ADDENDUM #2

Project: Ogden-Hinkley Airport
Front Terminal Expansion

Project Manager: Steven Lund AIA
Project Number: 2021-10
Date: 7.19.24

E060

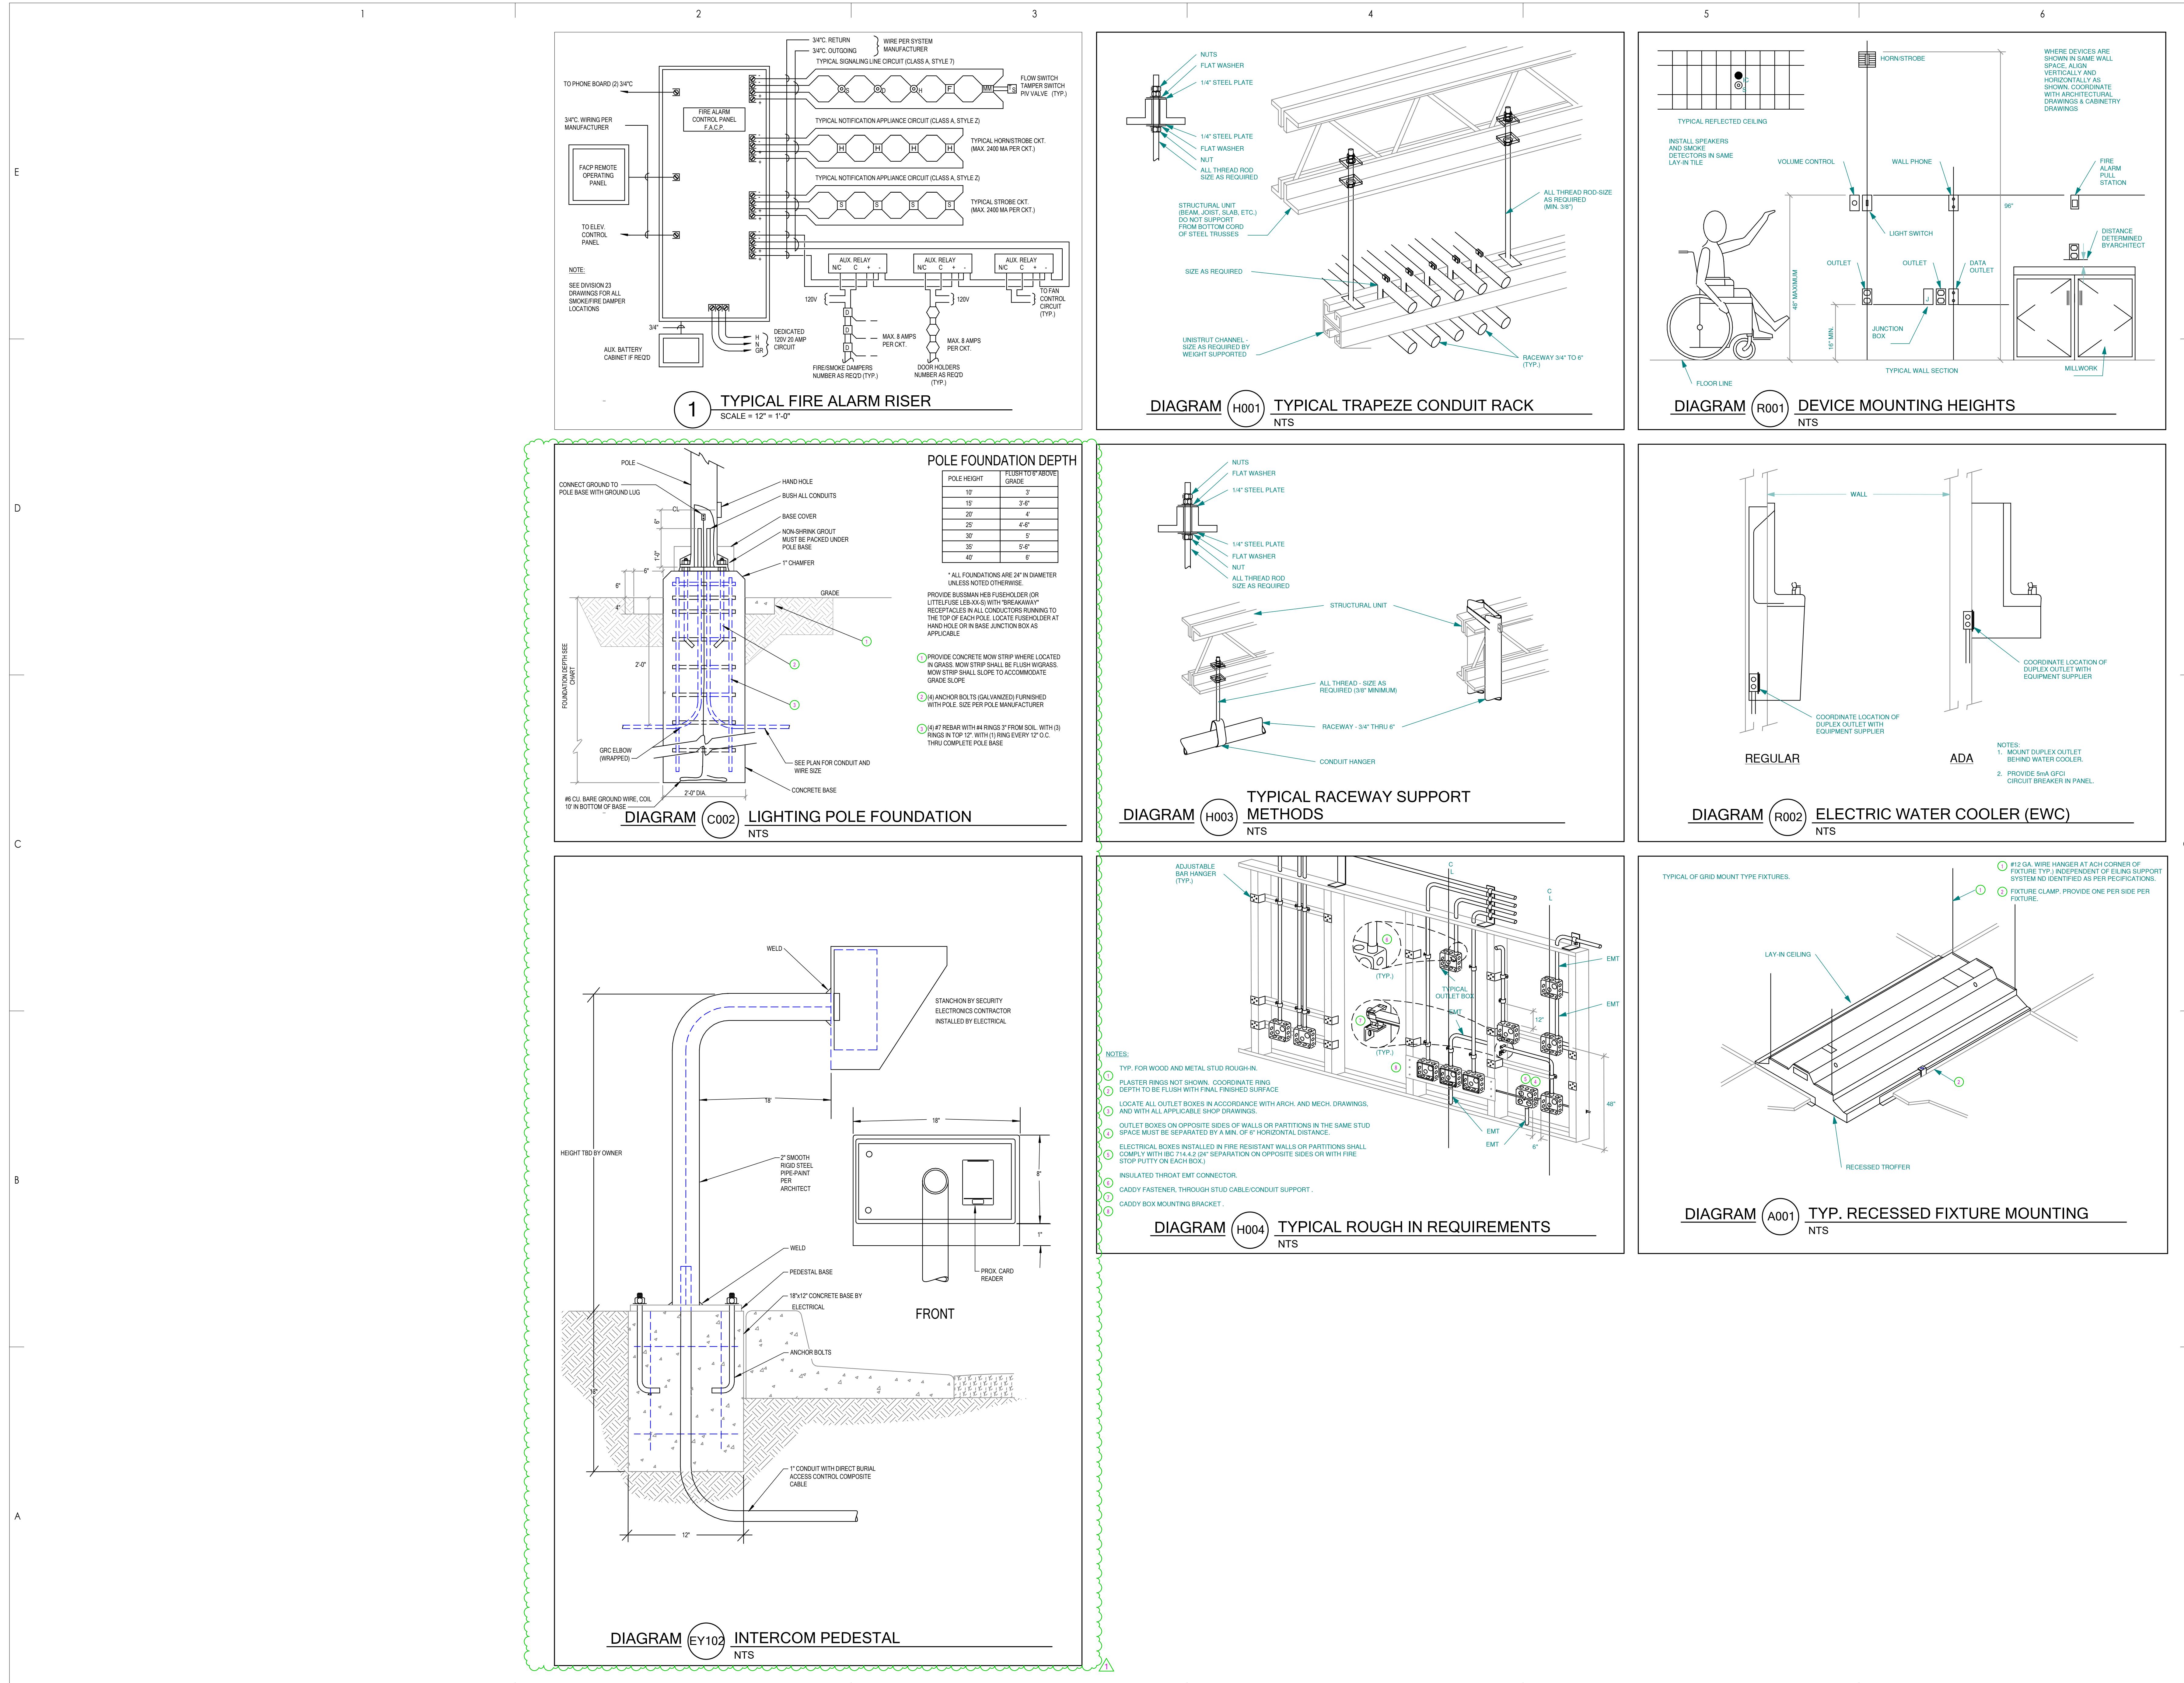
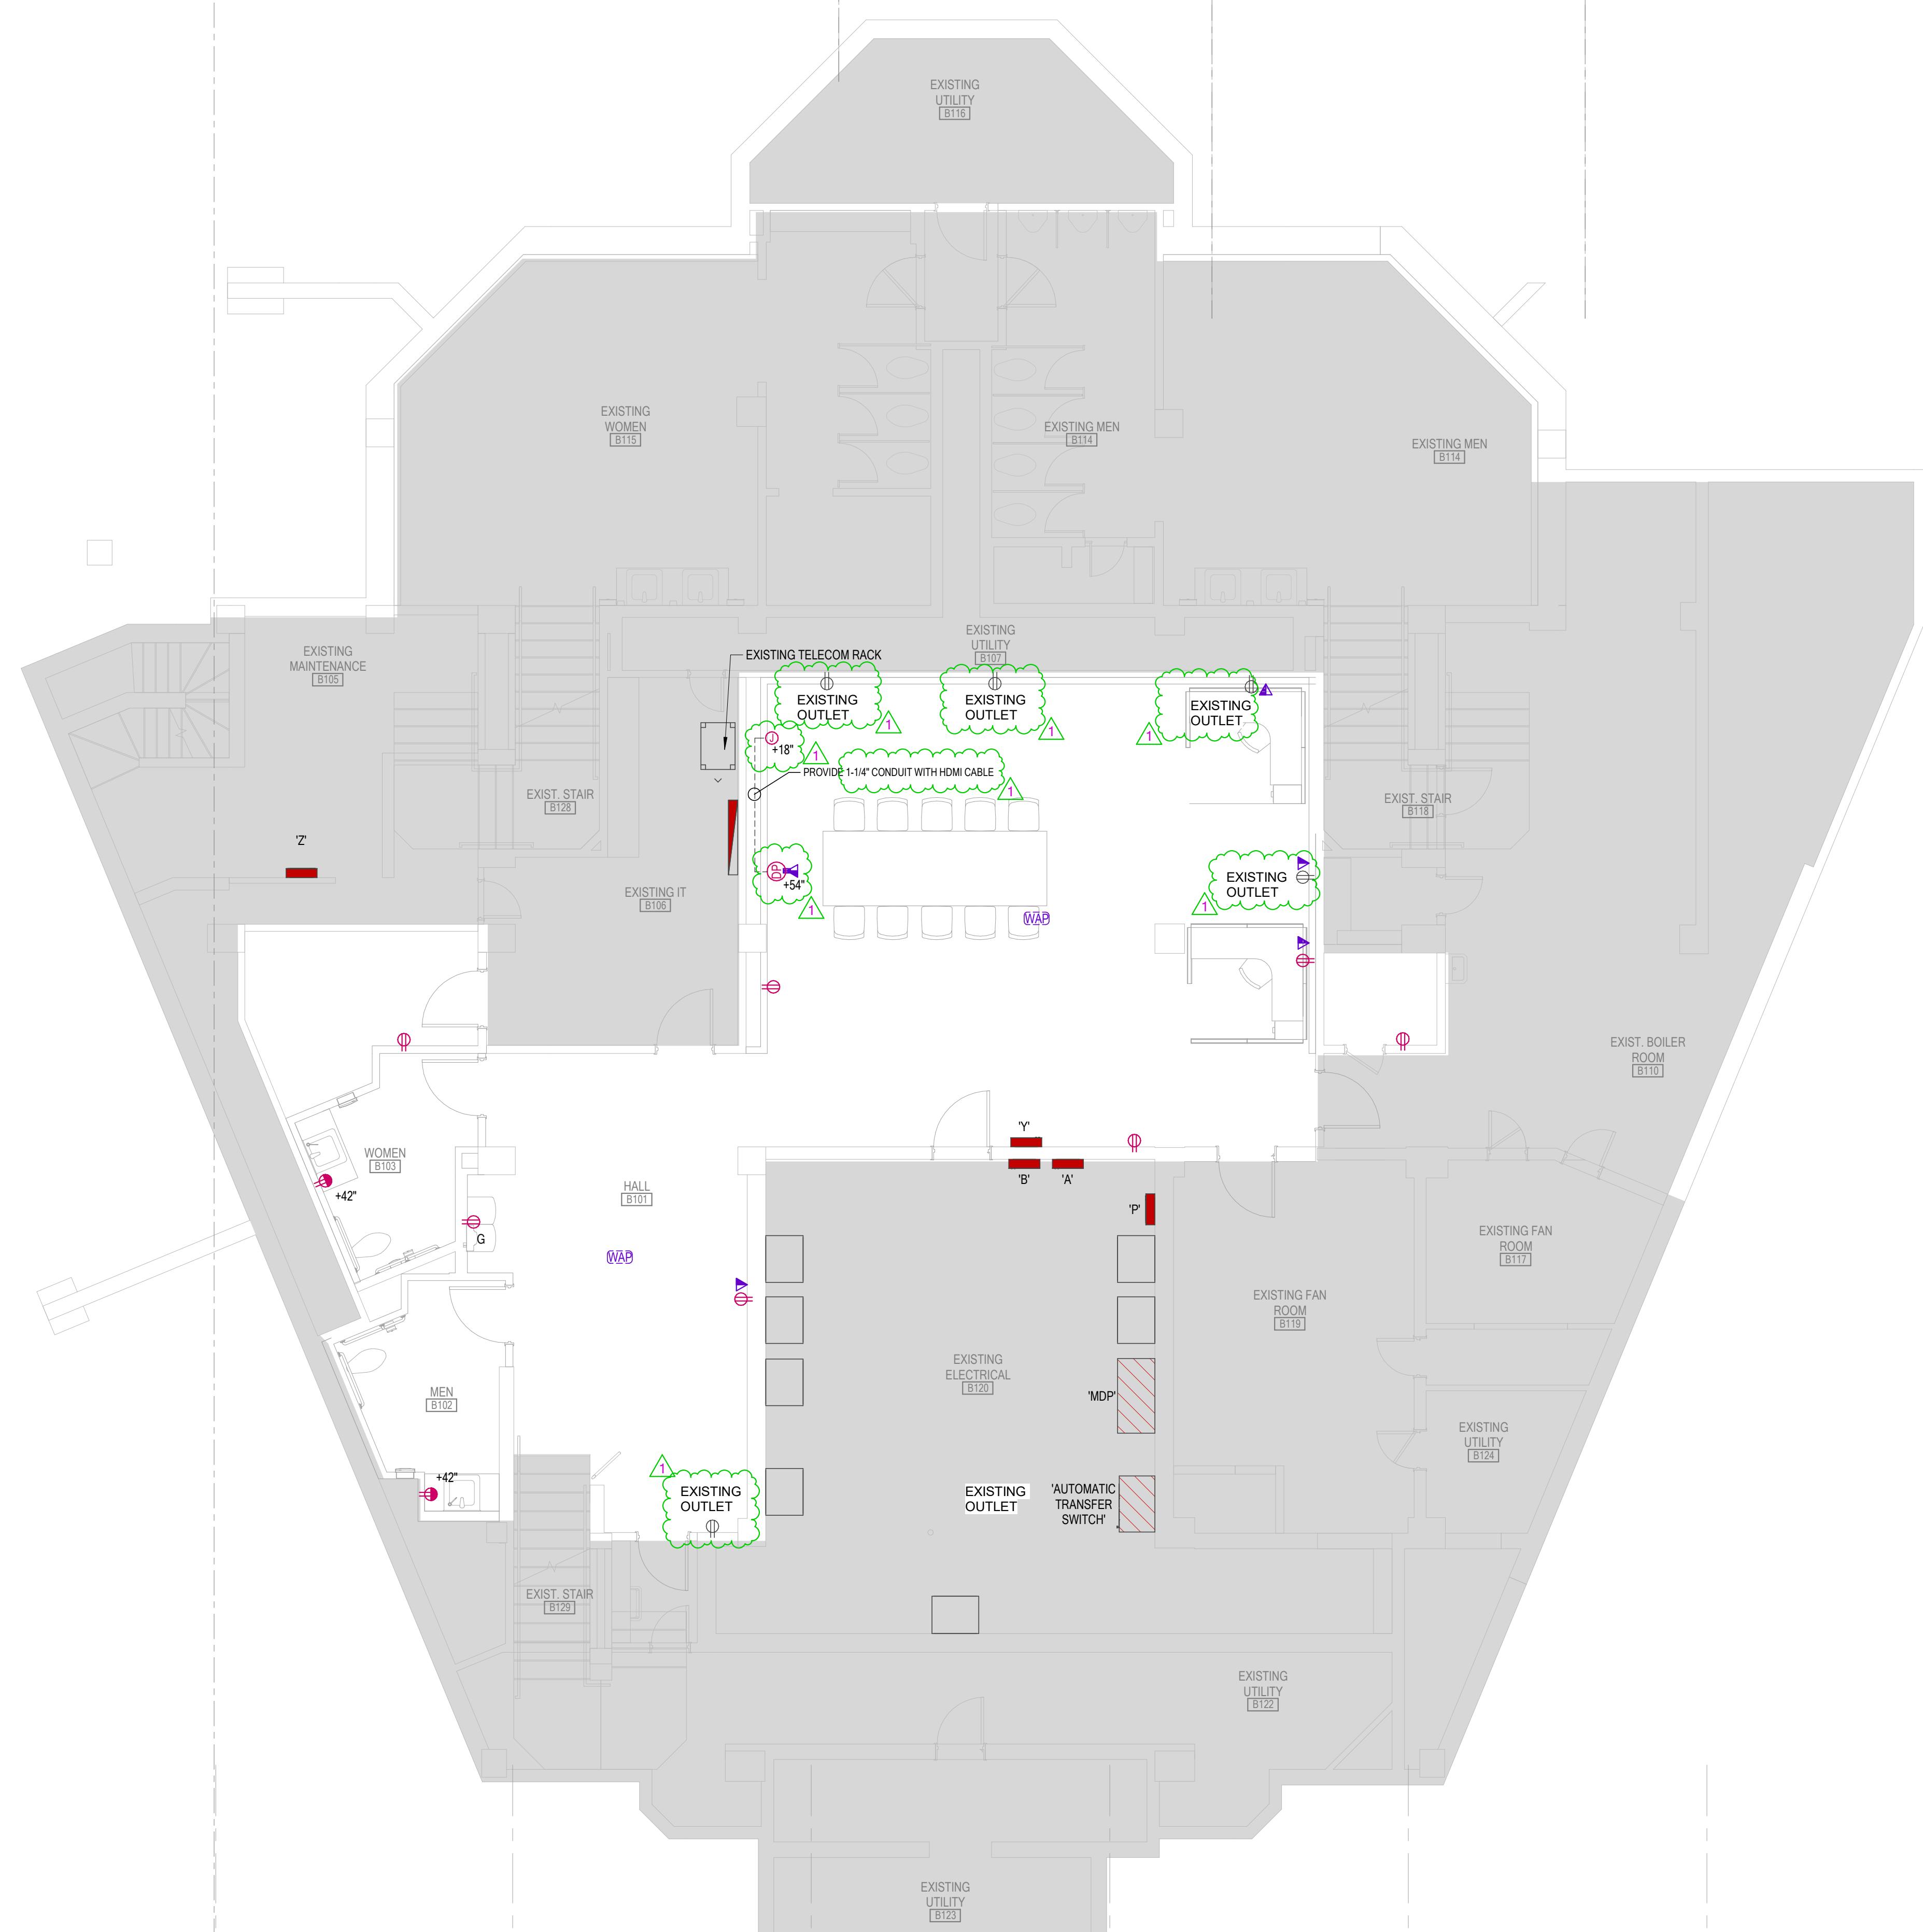
1. **SHEET E002**
 - a. Update light fixture schedule.
 - b. Change starter type for unit heater.
 - c. Add floor box schedule.
2. **SHEET E060**
 - a. Add diagrams C002 and EY102.
3. **SHEET E104**
 - a. Add diagram callouts.
4. **SHEET E200B**
 - a. Change S4 light fixture to S4H.
 - b. Change WS1 light fixture to S4H.
 - c. Change S4.
5. **SHEET E300**
 - a. Add note for existing outlet.
 - b. Add height for display panel.
6. **SHEET E301C**
 - a. Add height for display panel.

E380

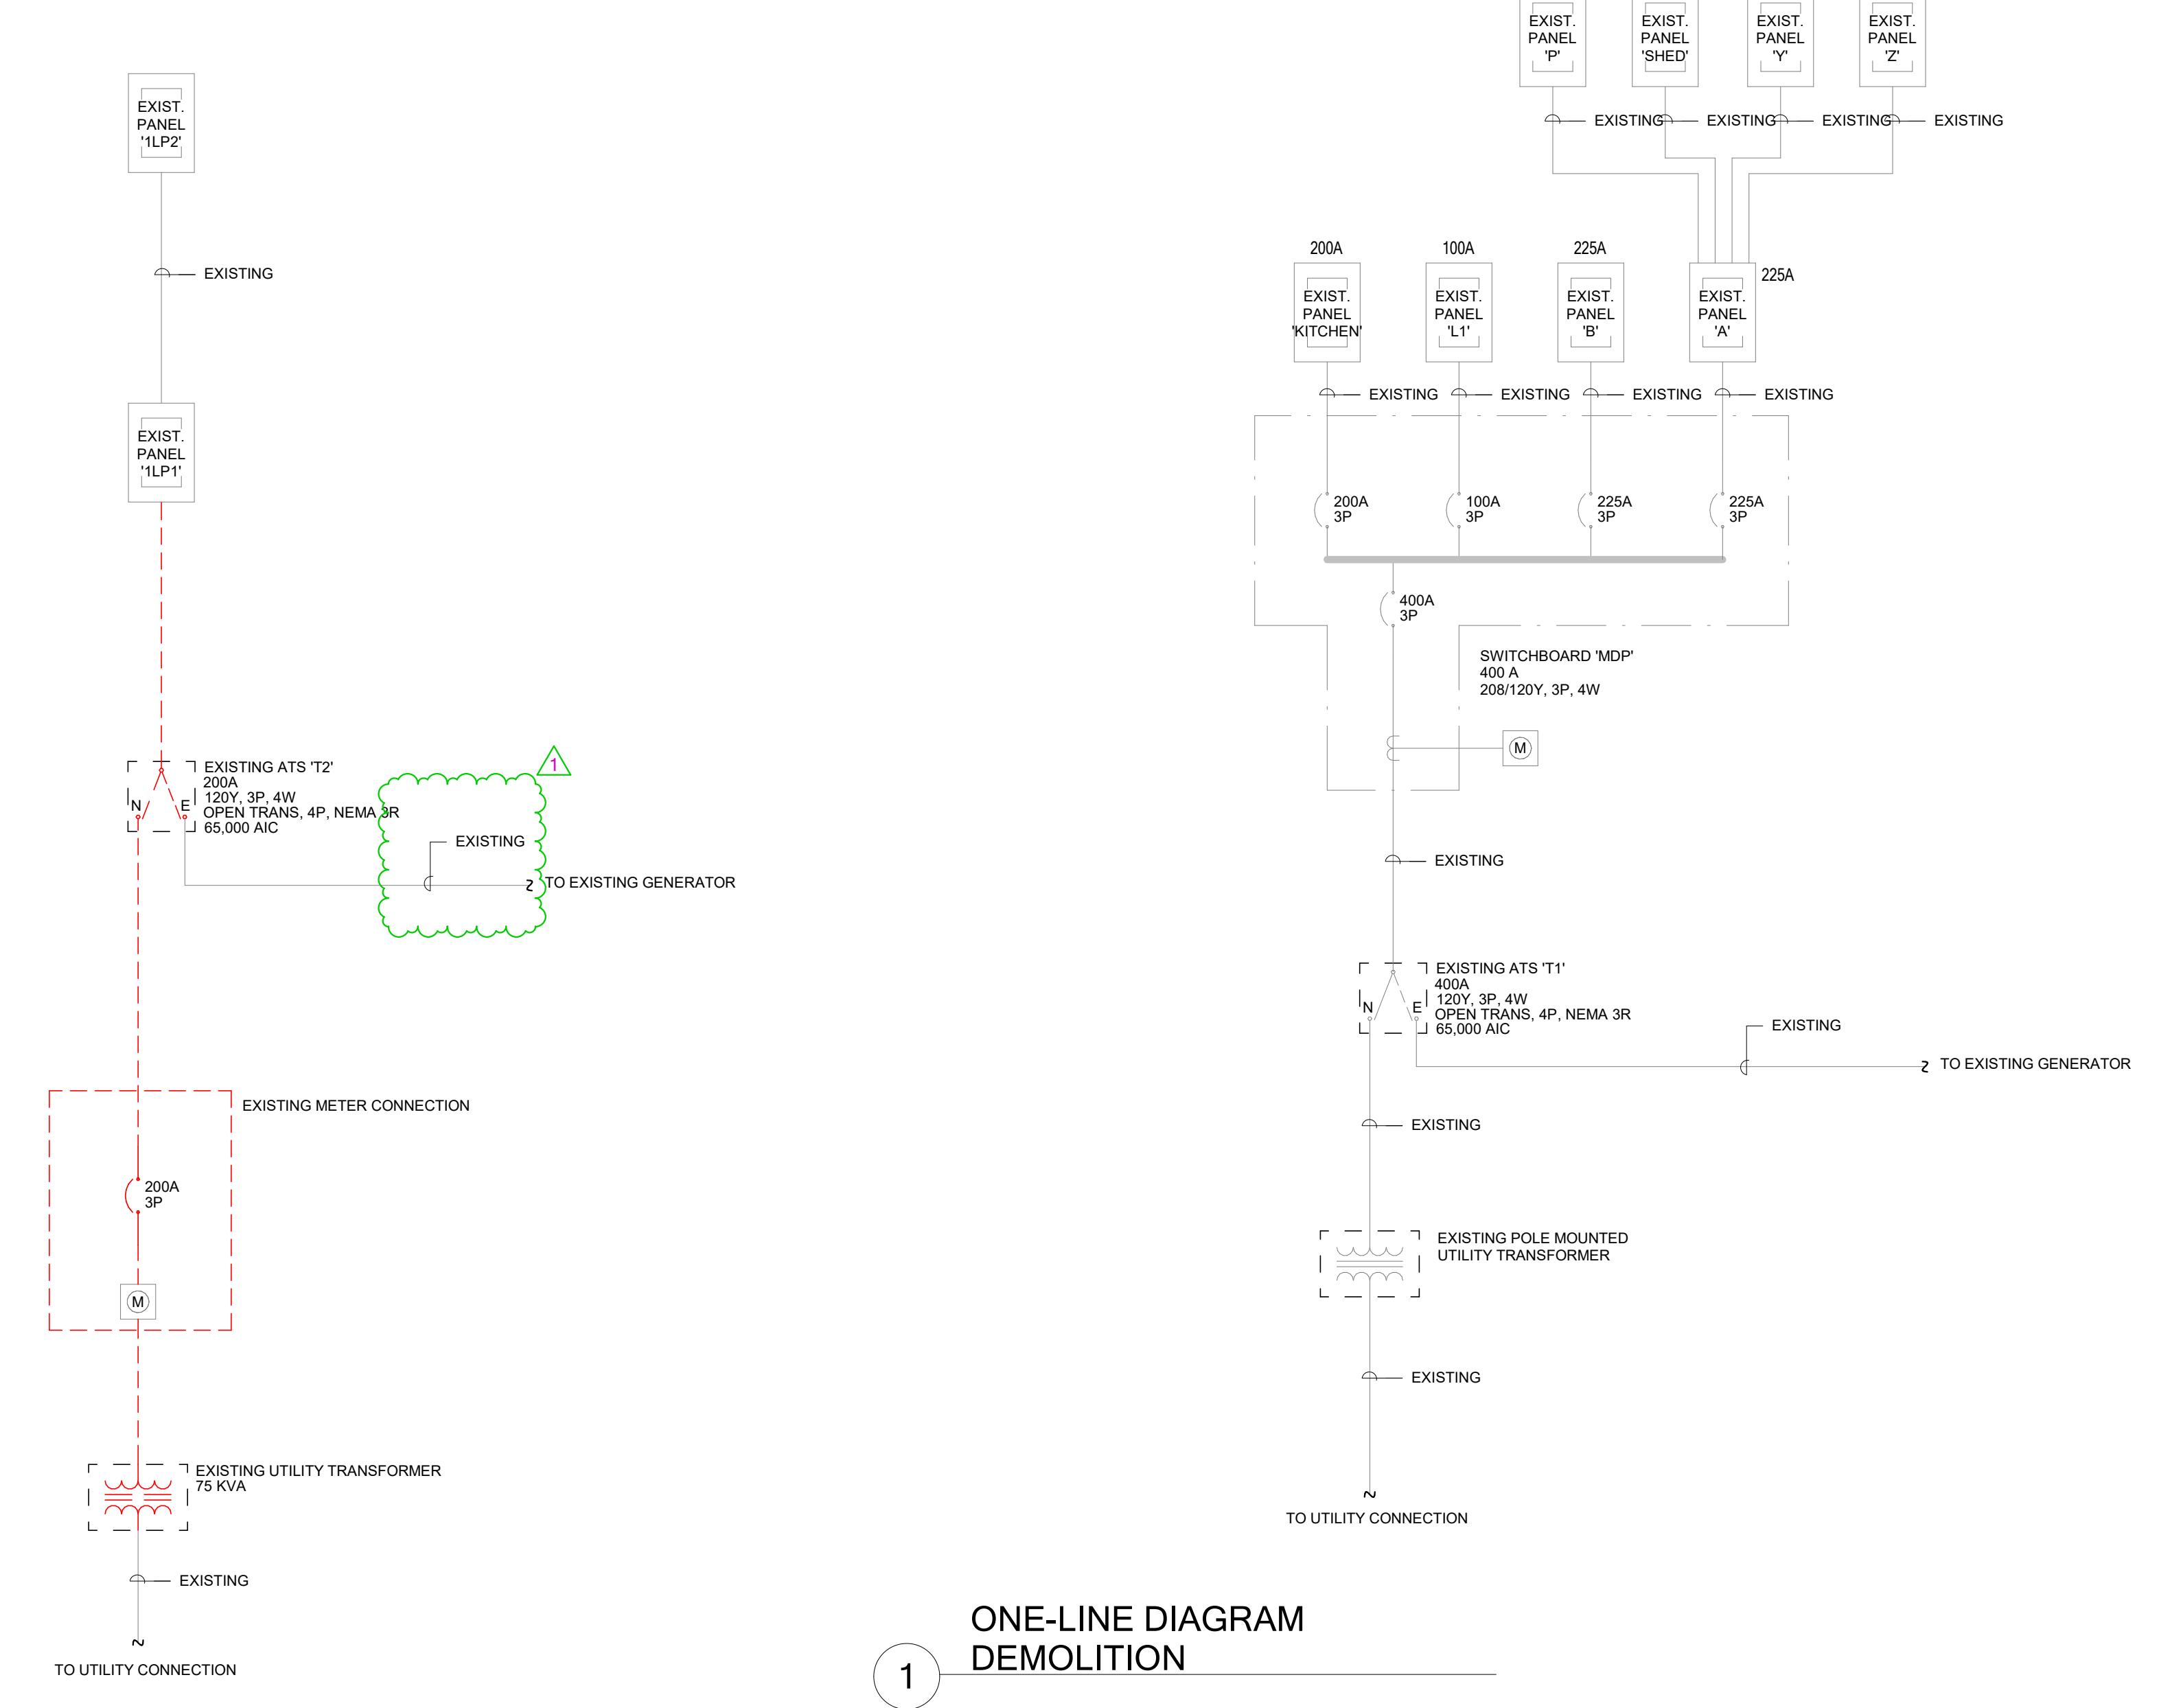
7. SHEET E380

- a. Change from demo to existing connection for generator.
